**NOACA**  
**Transportation Advisory**  
**Committee**

# Cleveland Innerbelt Plan Design Concept: June 2004

# Central Viaduct: Existing Alignment

Figure 7-6: Northern Hybrid Alternative

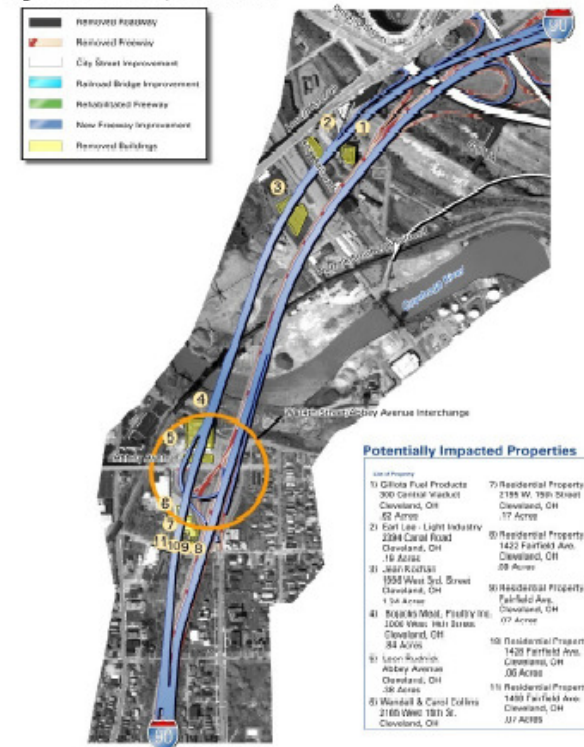
- **A SIGNATURE BRIDGE ?**
- It fails the “Complete Streets” Test - A Complete Street is safe, comfortable and convenient for travel via automobile, foot, bicycle, and transit.
- Current Plan - Lacks Bicycle & Pedestrian Accommodation
